Docket Number:	21-AFC-02
Project Title:	Willow Rock Energy Storage Center
TN #:	259736
Document Title:	Willow Rock Data Request Set 4 Response
Description:	N/A
Filer:	Kathryn Stevens
Organization:	WSP USA Inc.
Submitter Role:	Applicant Consultant
Submission Date:	10/28/2024 4:49:53 PM
Docketed Date:	10/28/2024

Willow Rock Energy Storage Center (21-AFC-02)
Data Request Response Set 4

October 2024

IF THIS MEASUREMENT DOES NOT MATCH WHAT IS SHOWN, THE SHEET SIZE HAS BEEN MODIFIED FROM: ANSI B 11

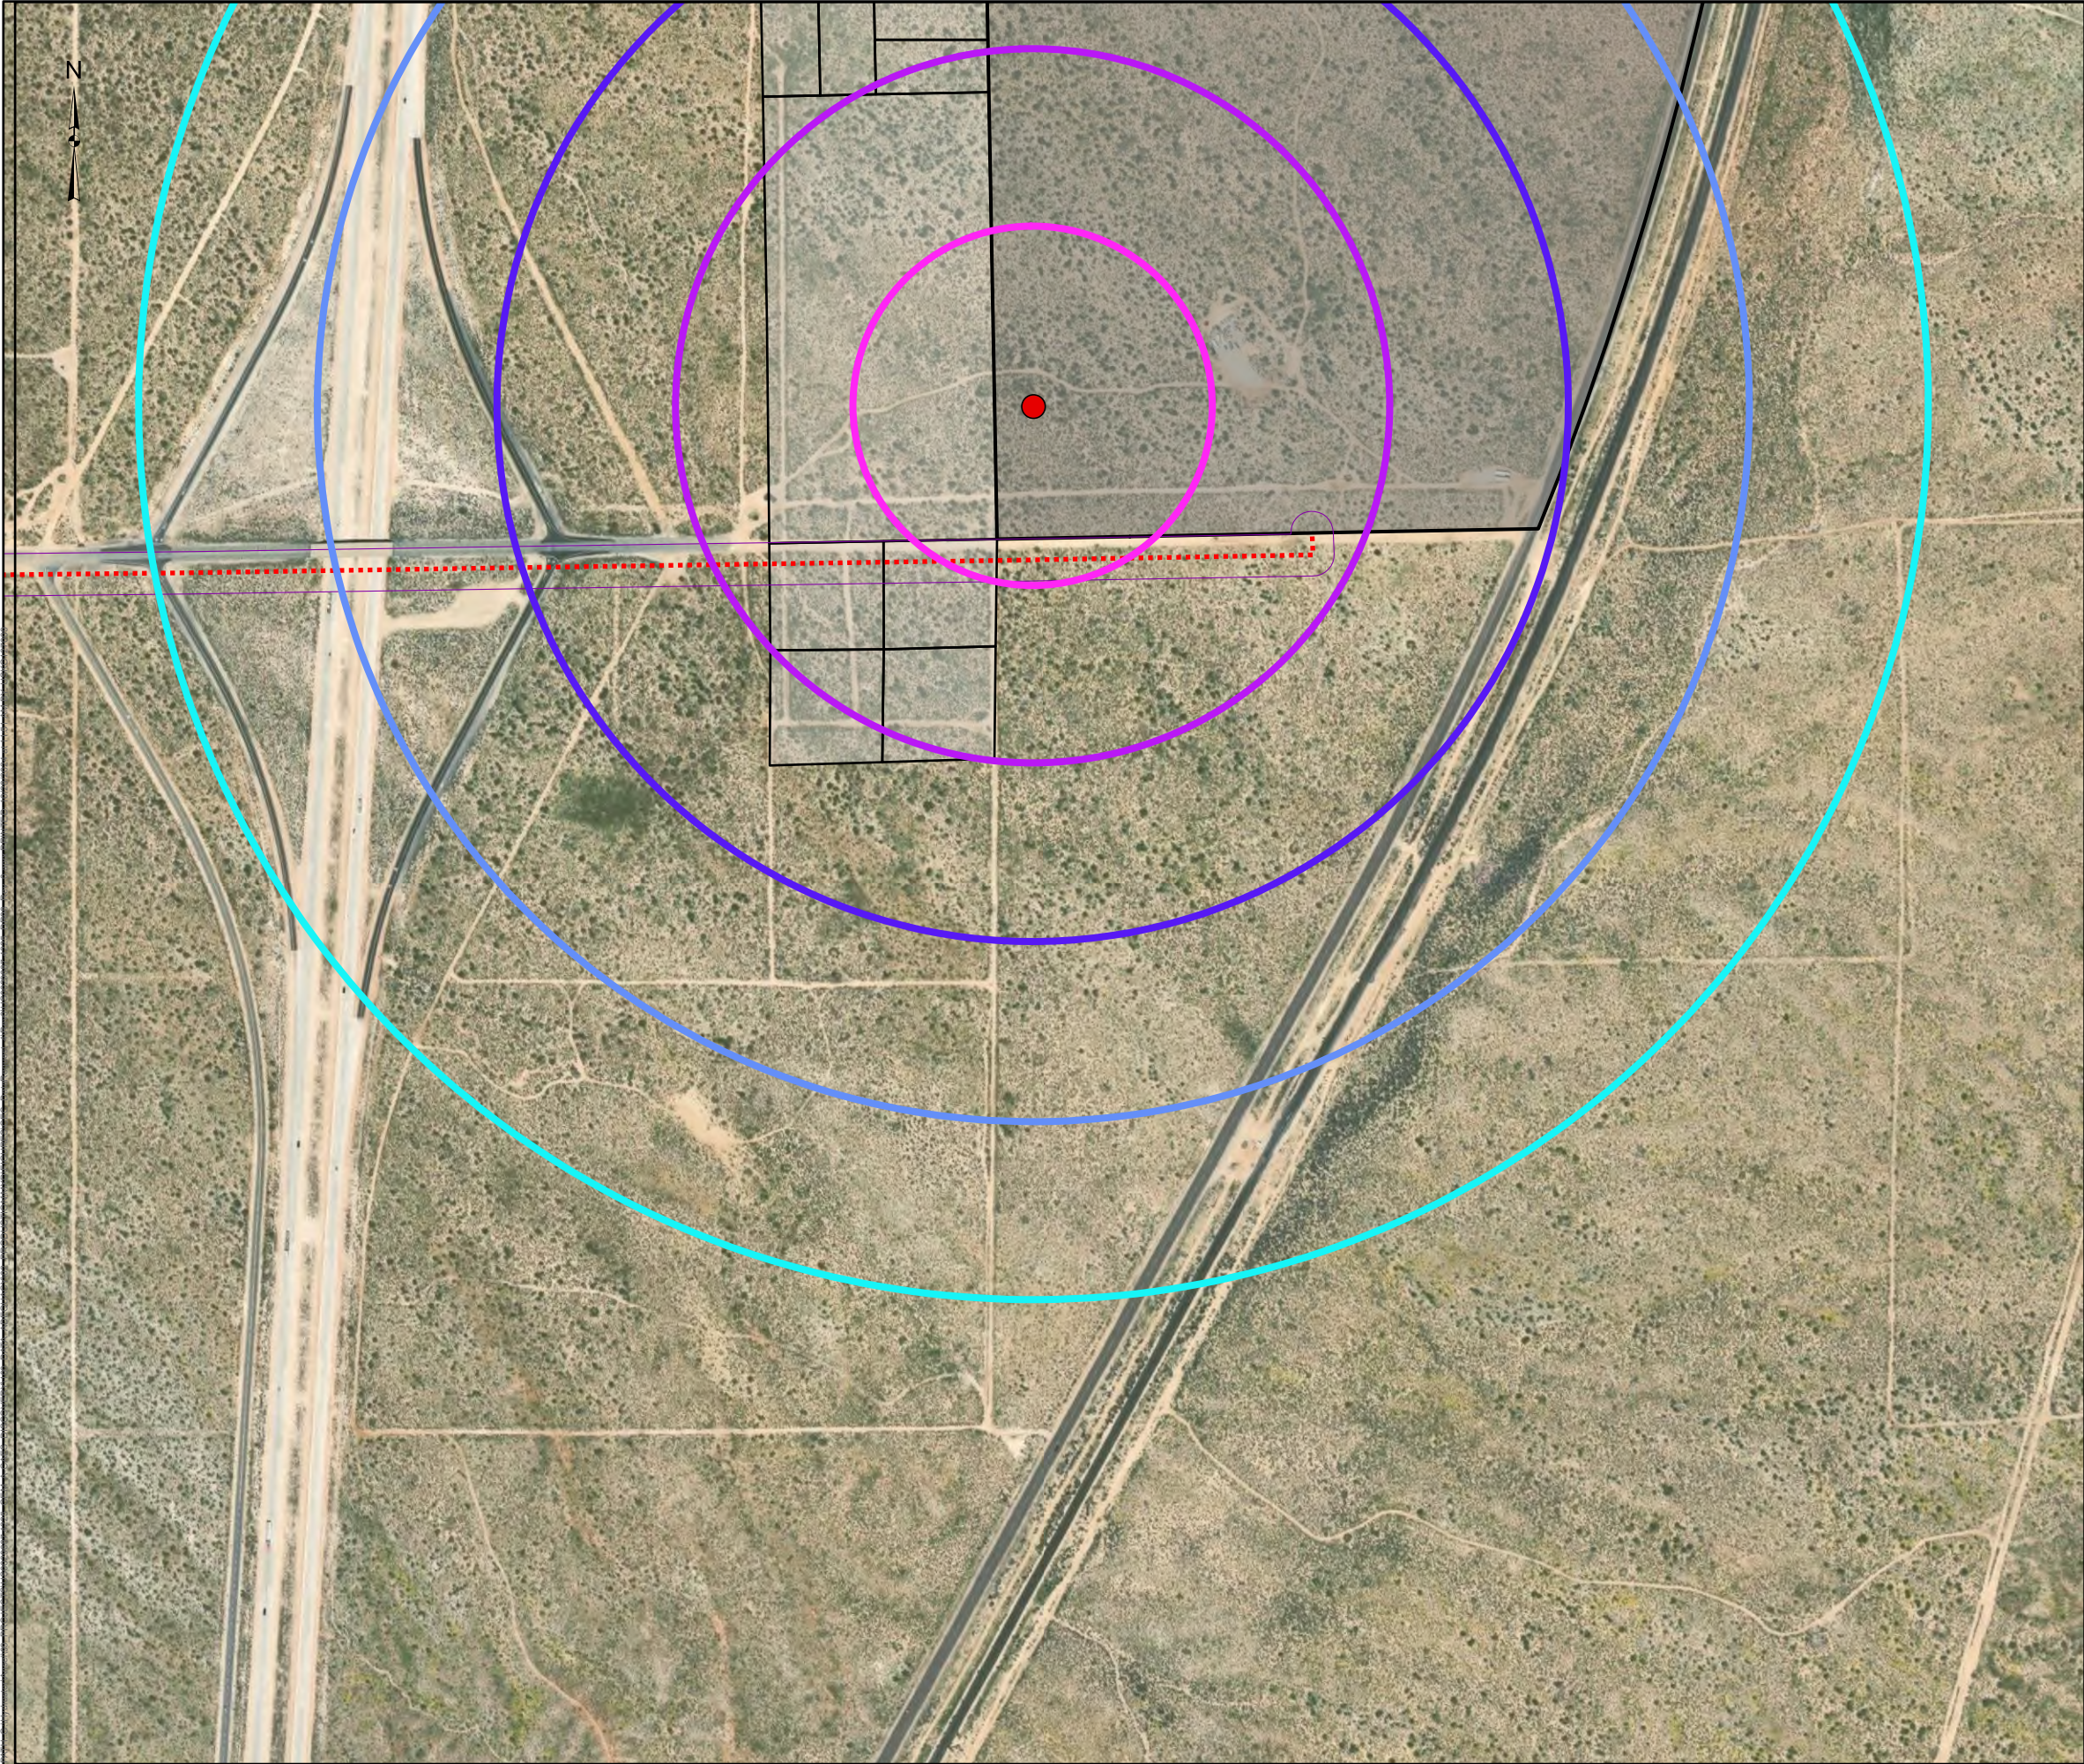
DR98: *Please provide an aerial imagery map (at a scale of 1:6000) showing the attenuation of sound and vibration out to 0.5-mile.*

Response: Figures depicting the attenuation of sound and vibration are provided in **Attachments DR98-1, Figures DR98A; Attachment DR98-2, Figures DR98B; Attachment DR98-3, Figures DR98C; and Attachment DR98-4, Figures DR98D.** Please note that these are extremely short events that last in most instances for less than a few seconds, with the longest duration in the 6-8 second range.
